TECHNICAL SERVICE BULLETIN

DATE ISSUED	MODEL YEAR(S) AFFECTED	TSB #
11/30/2015	2012-2013	438
BRAND		
Bay Star Sport <input type="checkbox"/>	Ventana <input type="checkbox"/>	Essex <input checked="" type="checkbox"/>
Bay Star <input type="checkbox"/>	Dutch Star <input type="checkbox"/>	King Aire <input checked="" type="checkbox"/>
Canyon Star <input type="checkbox"/>	Mountain Aire <input type="checkbox"/>	Other <input type="checkbox"/>
Ventana LE <input type="checkbox"/>	London Aire <input type="checkbox"/>

SERVICE BULLETIN

SUBJECT: Spartan Motors Chassis, Inc. has determined a defect relating to the modulator valves making contact with the IFS relay rod may exist in certain vehicles equipped with IFS2000 model front suspension.

FIG. 3-1

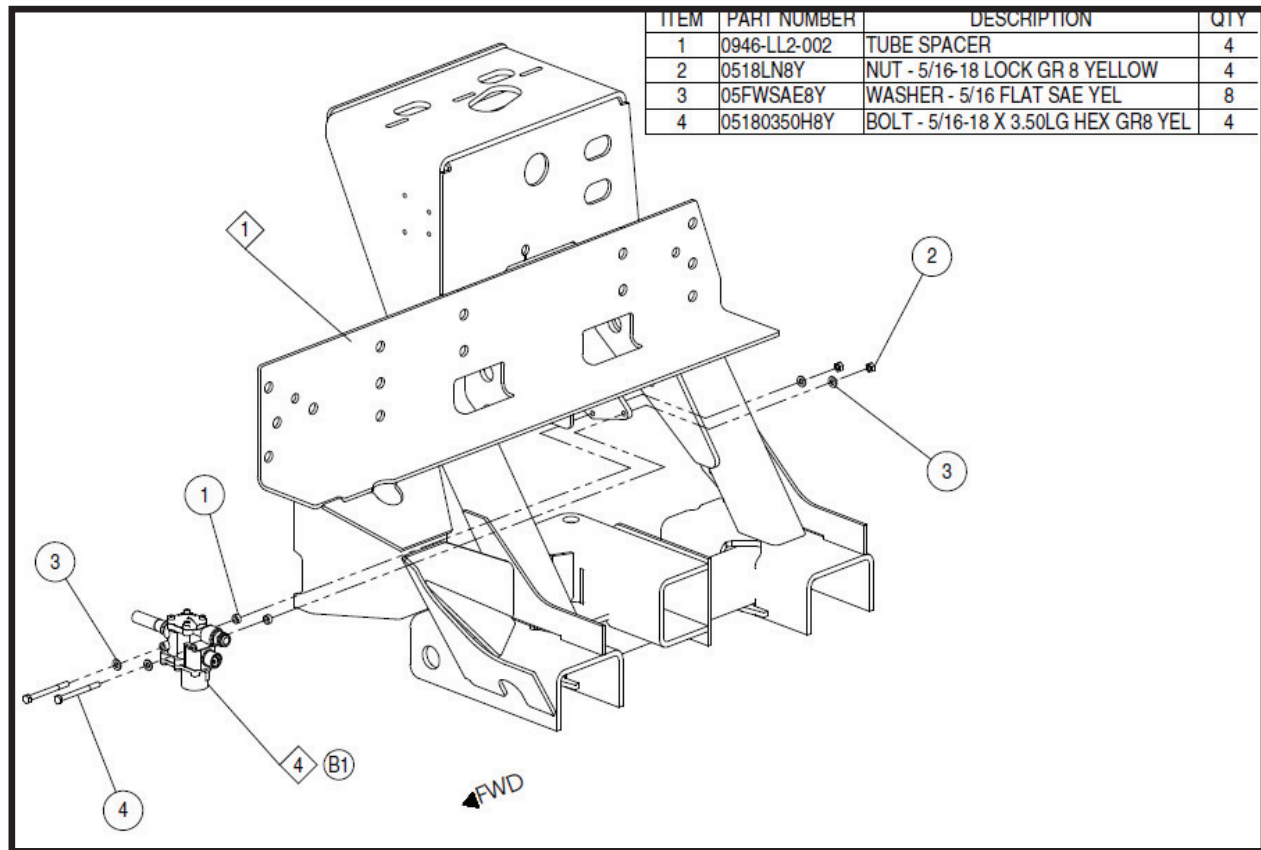
2. Remove (2) 5/16 in. bolts, (4) washers, and (2) nuts that mount ABS modulator valve to suspension. Retain washers and nuts for reuse. Refer to FIG. 3-1.

3. Install spacers between ABS modulator valve & mounting plate. Refer to FIG. 3-1.
4. Install new bolts, retained washers, and retained nuts. Torque nut side to 15 lbs. ft.
5. Repeat steps 2 through 4 for opposite side.
